Reviewed for Code Compliance  
Inspections Division  
Approved with Conditions

FIRST FLOOR  
68 DEERING ST

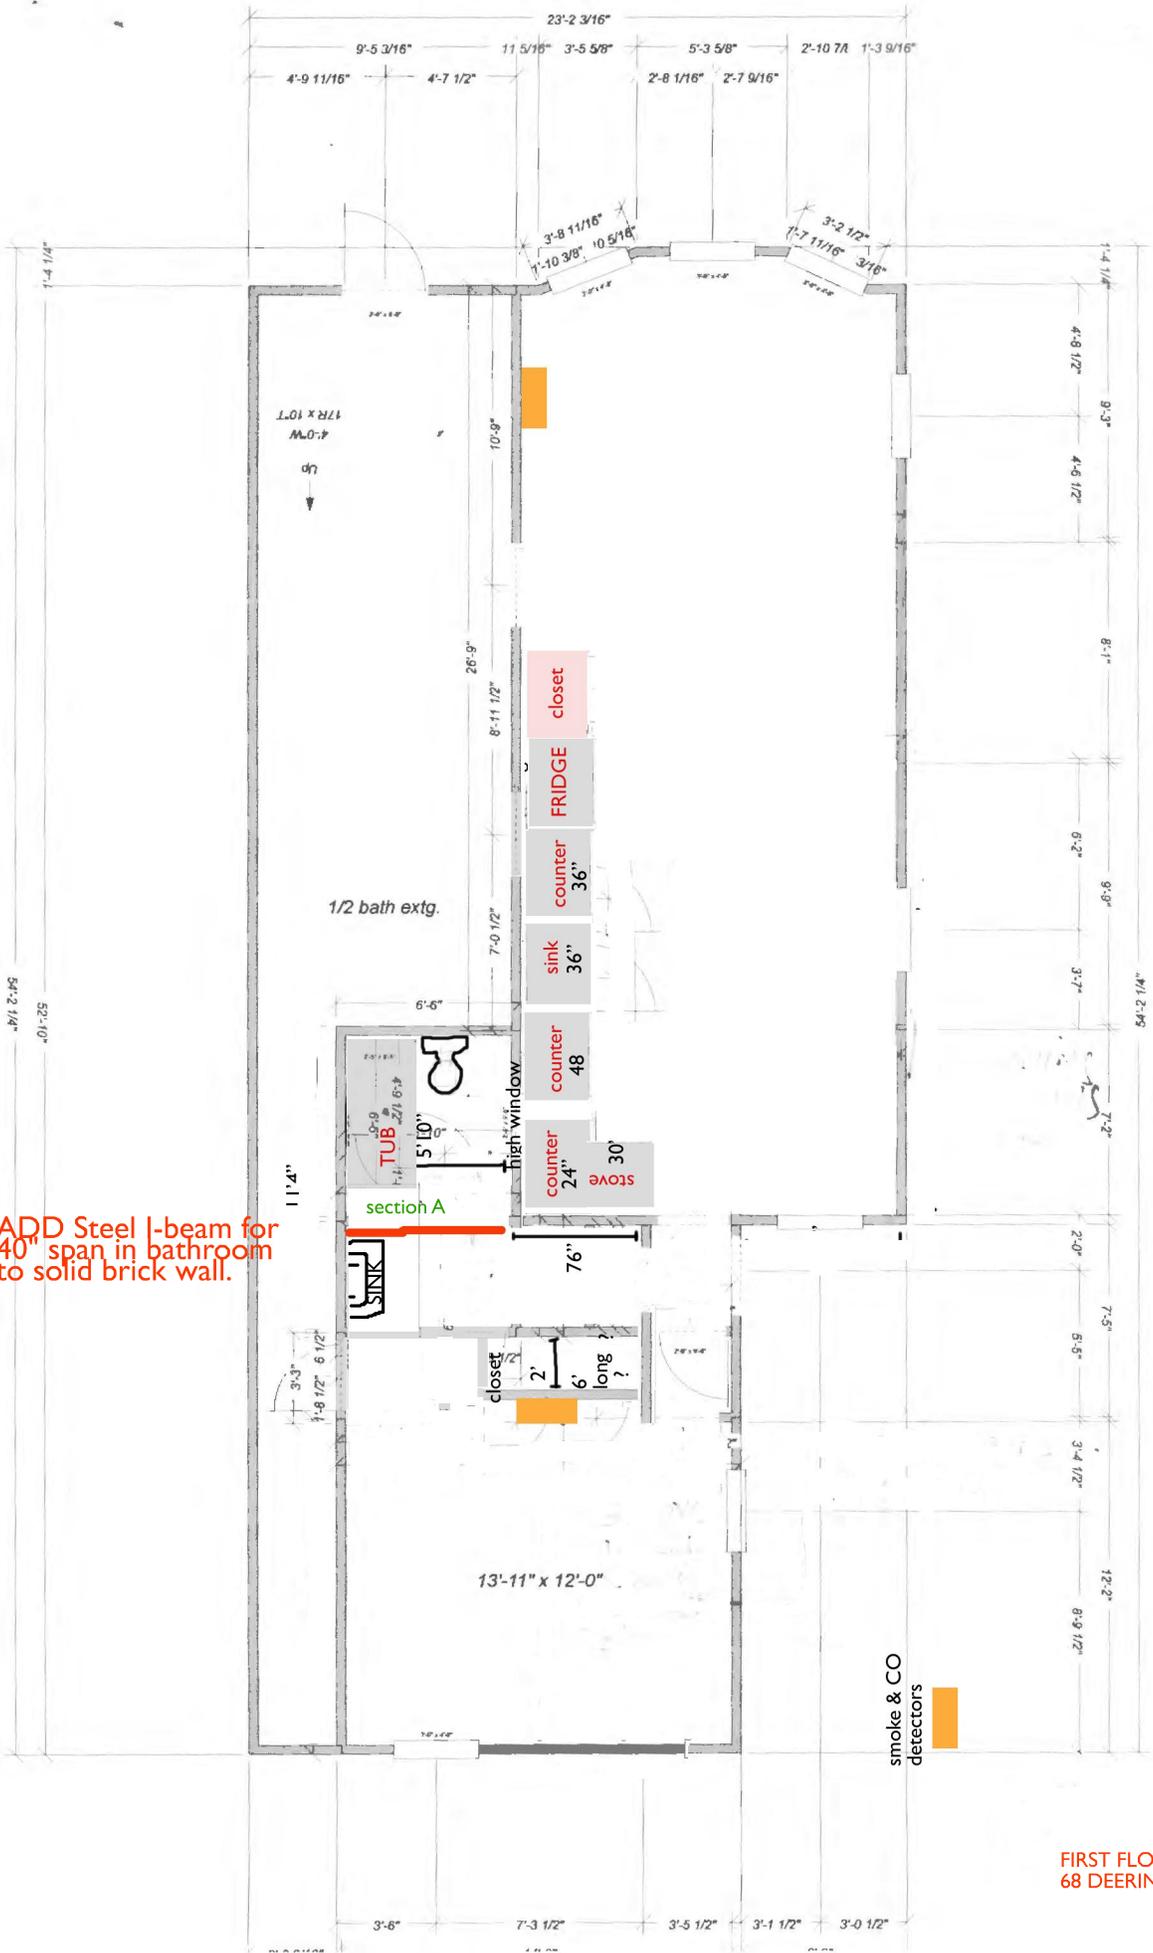
ADD Steel I-beam for 40" span in bathroom to solid brick wall.
